Re: O.J.H.R.P. Project No. 24,
New Liskeard Embankment
W.J. 62-F-99.

Re: Installation at O.N.R. Overpass - Tri-Town By-Pass

LSP-104-60-2
RE: R. D. C. E.
Procedure
C.N.R. Overpass at
New Liskeard.

Re: C.N.R. Bypass Six-Town Bypass
District (New Luskboard) W.P. 104-60

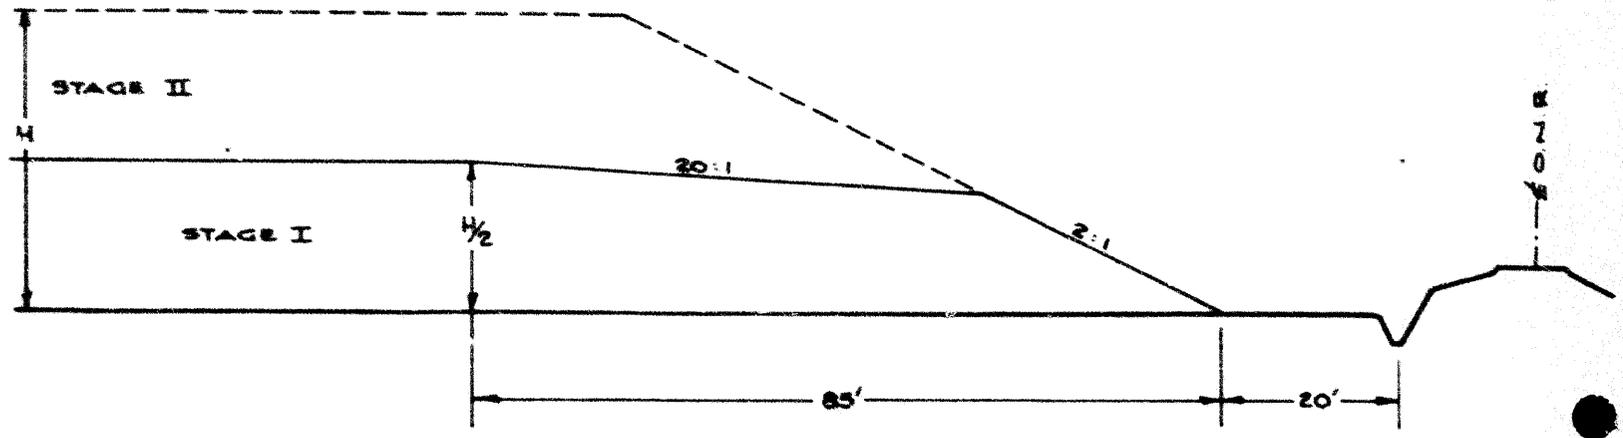
Attached to this memo, you will find Drawing No. X-29 showing the recommended construction sequence of the approach embankments. Stage No. 1 can be started whenever desirable or convenient, while the time for the start of Stage No. 2 will be determined by the Foundation Section.

- 1) Large settlements that would have been detrimental for the structure, will already have taken place by the time the structure will be built.
- 2) The full height of embankment will be built without berms.
